New Reactors Programme
GDA close-out for the AP1000 reactor
GDA Issue GI-AP1000-FS-01: Spent Fuel Pool Safety Case

Assessment Report: ONR-NR-AR-16-022
Revision 0
March 2017

This report is the Office for Nuclear Regulation's (ONR's) assessment of the Westinghouse **AP1000** reactor design in the area of fault studies. Specifically, this report addresses GDA Issue GI-AP1000-FS-01: Spent Fuel Pool Safety Case.

Figure 1: Illustration of key elevations during fuel handling operations in the spent fuel pool

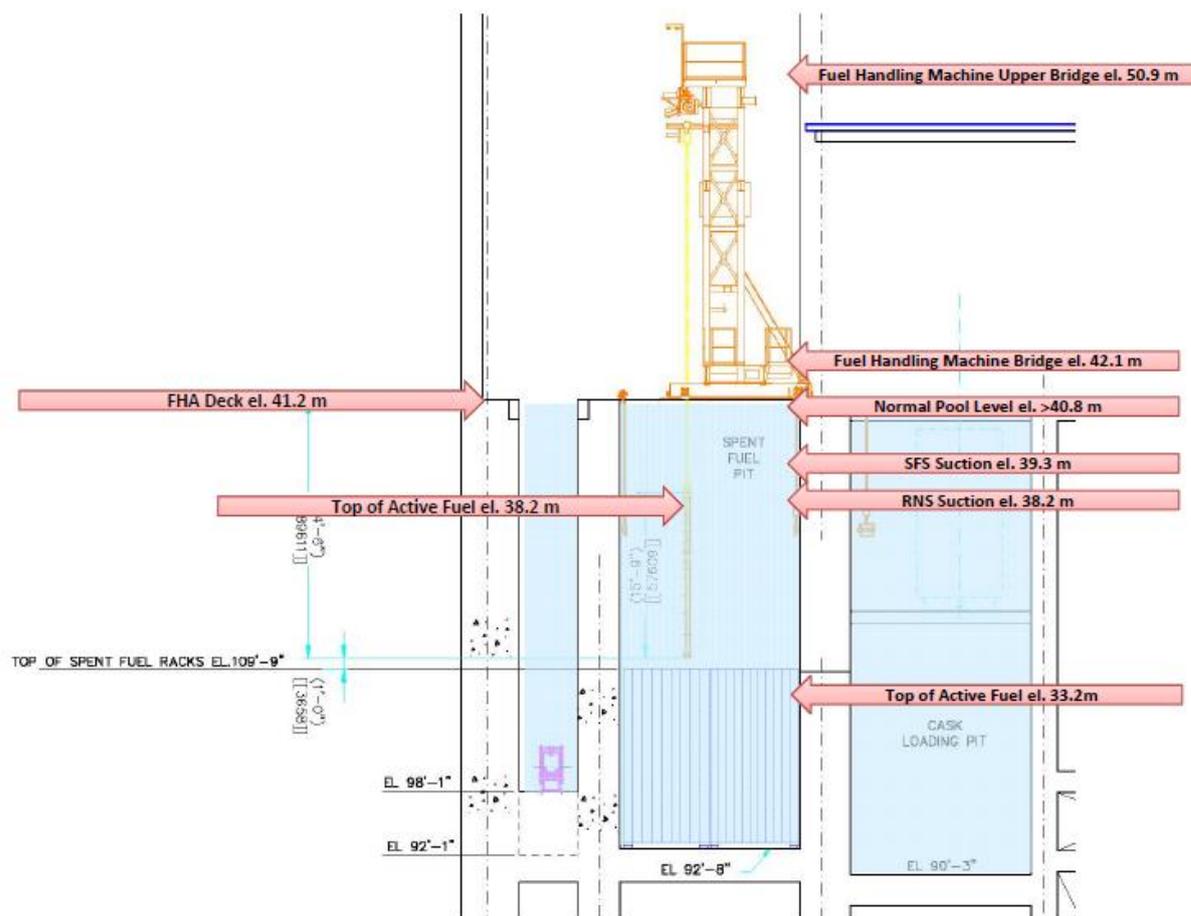
94. For loss of cooling events associated with a pipe break (including a seismic event), Westinghouse has assumed the water level instantaneously drops to the level of the non-seismically qualified SFS suction pipe.⁴ This is still well above the spent fuel racks but is only 1.0 m above the fuel assembly being handled. This is illustrated in Figure 1.

95. Westinghouse has used the Microshield® computer code to undertake point-kernel gamma shielding calculations (Ref. 24). It has estimated that the dose rate to a worker should be less than 20 mSv, assuming the lowering operations take circa one hour and the worker is at the maximum dose location throughout that period. With more realistic assumptions about where the operators will be positioned to perform the different actions required to lower a fuel assembly into a safe location, Westinghouse has estimated a dose of less than 7 mSv could be anticipated. At face value, these evaluations do appear to support Westinghouse's claims and meet the requirements of SAP Target 1. However, Westinghouse did concede in discussions with ONR that its point-kernel gamma radiation calculations are not as accurate as methods using Monte Carlo techniques. Westinghouse also noted that it had not considered the contribution of neutron exposure which could be significant with only 1 m of water coverage.

96. Recognising this, Westinghouse has stated it will undertake further calculations during site licensing to confirm its initial estimates. If necessary, it will provide additional shielding to the fuel handling machine deck (the location of the highest dose) to achieve the appropriate dose levels.
